Bury Highways Response – Wednesday 18th December 2024

Applicant Response – Wednesday 18th December 2024

The bridge line is marked on the Highways GA Plan, please note the extract below.

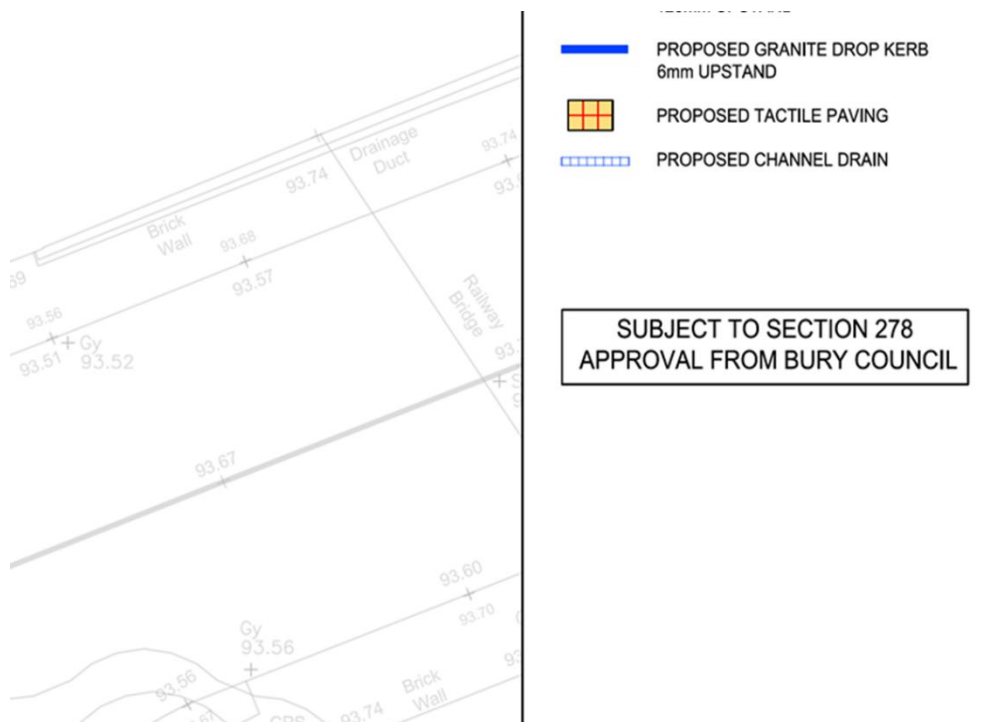
“In relation to “Figure 2.2.2- Site Access Logistics – Week 1-37” shows vehicles arriving on Fairfax Road from Bury New Road and turning on site as discussed, but will need amending to show vehicles then turning right from the site onto Fairfax Road to return to Bury New Road. Currently showing vehicles turning left from the site onto Fairfax Road towards Heys Road is not acceptable due to the environmental concerns/impact on residents of that route.

Figure 2.2.2 has been updated as requested. Please find attached Rev H of the Project Execution Plan (PEP). A copy of the latest Highways GA is also attached for reference.

Figure 2.2.2 is a mark up of the attached Highways Works Plan to indicate how vehicles will access and egress the site. Vinci have taken an extract of this plan and annotated it with arrows, timescales and a key. The page within the PEP document clearly conveys the strategy it is intended to communicate.
